RE: Kingswood Apartments
181 unit apartment building with associated landscaping, open space, road improvements, parking and infrastructure.
TUM-21-1627
Formal Site Plan Approval

The City grants formal site plan review for the project subject to the conditions in this letter and attached site plan.

SITE PLAN / LIGHTING PLAN
SCALE: 1"=20'

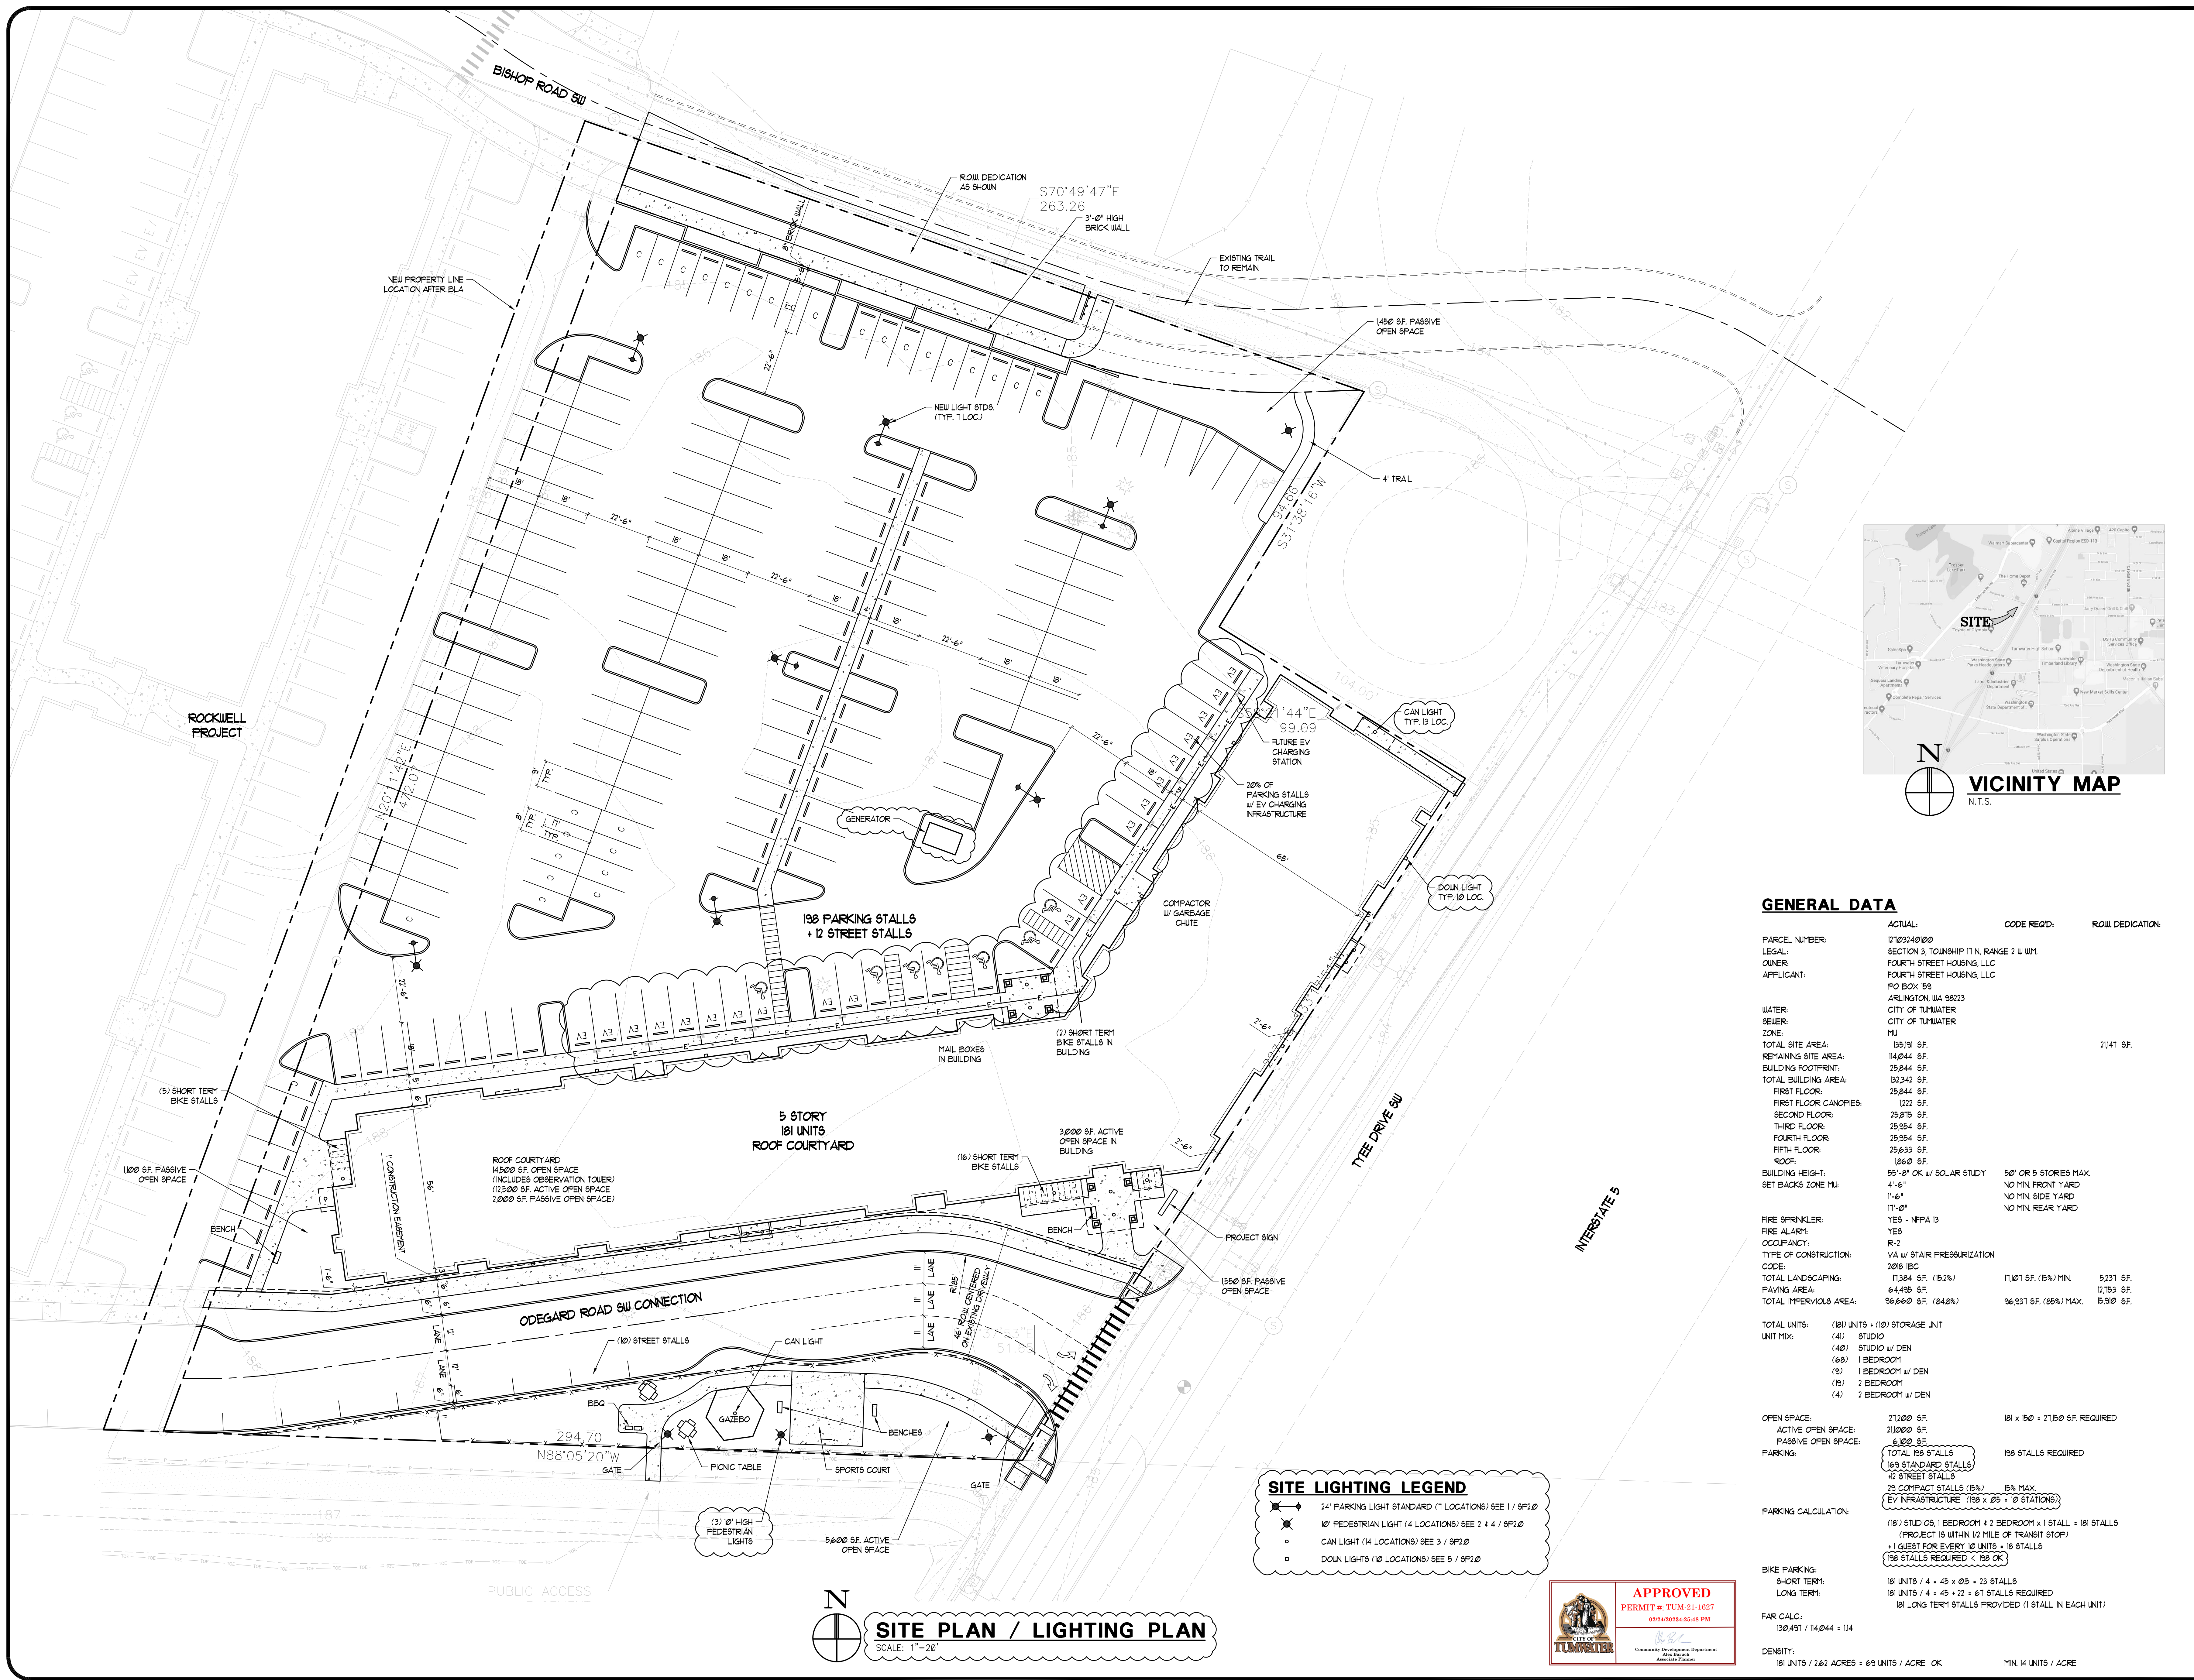
11. Site plan modifications may occur as a result of the engineering review process. For engineering issues, the approved engineering plans take precedence over the approved site plan.
